ADDENDUM 1

Client: Indiana University
Project: NW 827 Anderson Library Conference Center Transformer Replacement
Client Project No.: 20222216
Applied Project No.: 23-111
Addendum No.: 1
Date: 3/24/2025

NW 827 Anderson Library Conference Center Transformer Replacement
Pre-bid Meeting Minutes

DEMOLITION NOTES:

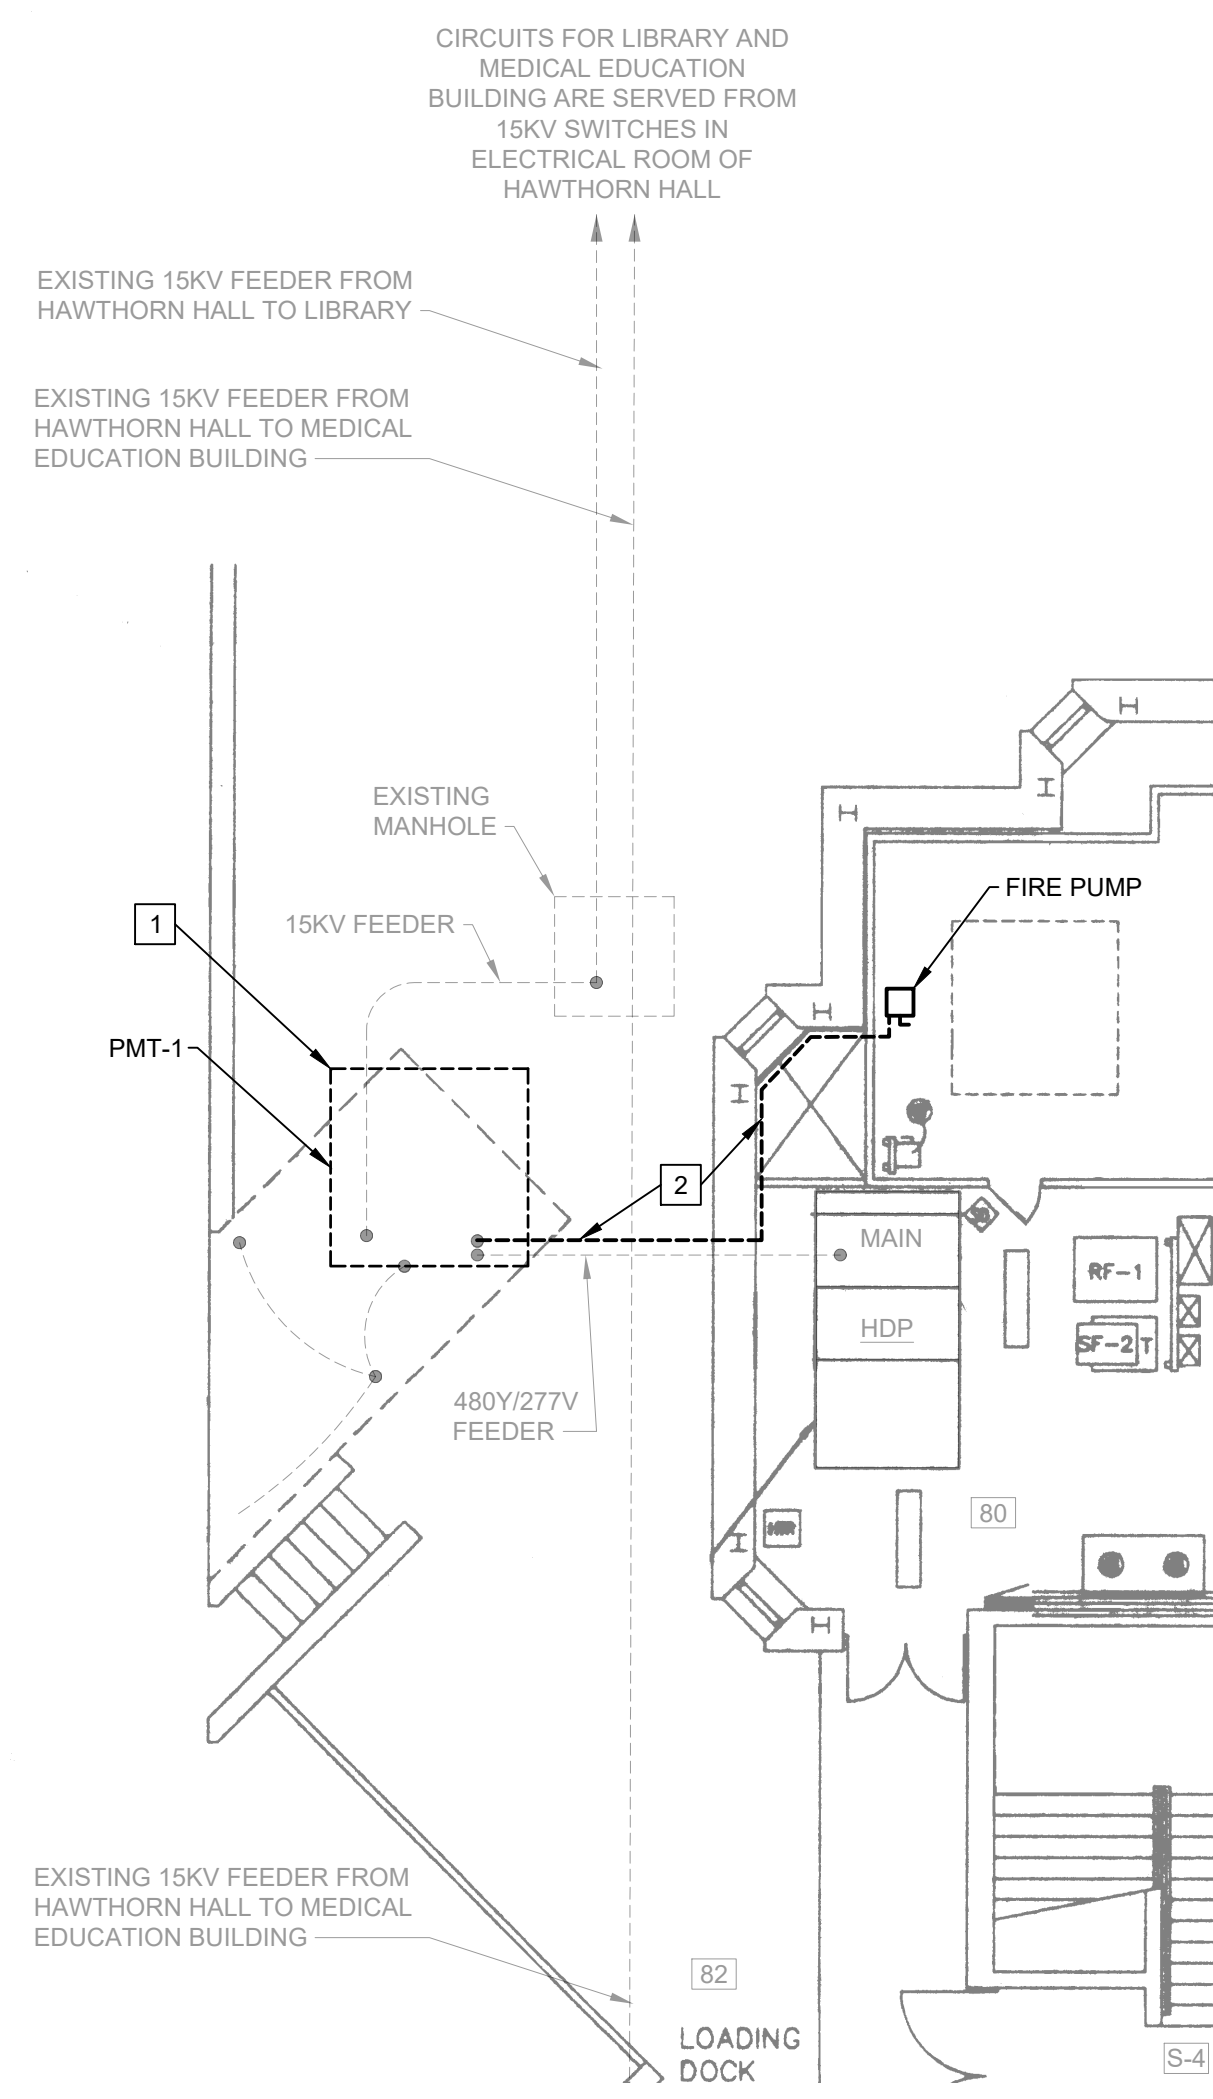
Drawing E301

1. Contractor to provide transformer.
2. Added Alternate # 1 – Provide refurbished transformer meeting current specifications.
3. Alternate # 2 – *Fire Pump Feeders: Contractor shall disconnect existing conductors and re-connect to newly installed transformer.*
4. Alternate # 3 – Contractor to drain existing transformer and make ready for storage. Contractor shall protect and store transformer for 6 months. Include all rigging and transportation from the project site and back to the project site. Contractor shall properly dispose of old oil and provide owner receipt of disposal.

7. An addendum to the construction documents is forthcoming. Items to include clarification of Plan Note 1 on sheet E301 to indicate the transformer is to be provided in its entirety by the contractor, not the owner. The addendum will also address the possible deletion of the fire pump feeder replacement pending engineering review.

- 1. PROVIDE PMT-1, PAD MOUNT TRANSFORMER, 2000KVA, 12.470V/480-277V, PADMOUNT, 5.75%Z. CONNECT TO EXISTING PRIMARY AND SECONDARY CABLING. PROVIDE GROUNDING PER DETAIL A ON THIS SHEET.
ALTERNATE #1 - PROVIDE REFURBISHED PAD-MOUNT TRANSFORMER CONFORMING TO ALL OTHER SPECIFICATIONS.

- 2. PROVIDE FEED FOR FIRE PUMP. 3" FIBERGLASS CONDUIT, (3) #20 & (1) #6GND POWER AND GROUND CABLING SHALL BE RADIX DURALIFE RHH/R90 TWO-HOUR FIRE-RATED CABLE. SEE CUT SHEET ON THIS PAGE. CONDUIT SHALL MEET CABLE REQUIREMENTS FOR 2 HOUR FIRE RATING. UTILIZE EXISTING OPENING IN BUILDING AND RUN CONDUIT ALONG EXISTING EXTERIOR WALL. SEAL OPENING IN BUILDING ENVELOPE TO BE WATER-TIGHT. CONDUIT ROUTES THROUGH EXISTING EXTERIOR WALL. PATCH AND PAINT WALL, AS REQUIRED. ROUTE CONDUIT ALONG WALL TO EXISTING FIRE PUMP PULL BOX LOCATED BELOW FIRE PUMP CONTROLLER.
ALTERNATE #2 - REUSE EXISTING FIRE PUMP CABLING. TERMINATE ON NEW TRANSFORMER.

- 1. REMOVE EXISTING PAD MOUNT TRANSFORMER. RETAIN SECONDARY AND PRIMARY CABLING AND TERMINATIONS.
- 2. REMOVE FEED FOR FIRE PUMP. REMOVE CONDUIT AND CABLE COMPLETELY. EXISTING FIRE PUMP CONTROLLER SHALL REMAIN AND BE PROTECTED. COORDINATE WORK WITH OWNER TO ENSURE BUILDING IS NOT OCCUPIED WITH DURING OPERATION OF FIRE PUMP.
ALTERNATE #2 - RETAIN EXISTING FIRE PUMP CABLING.
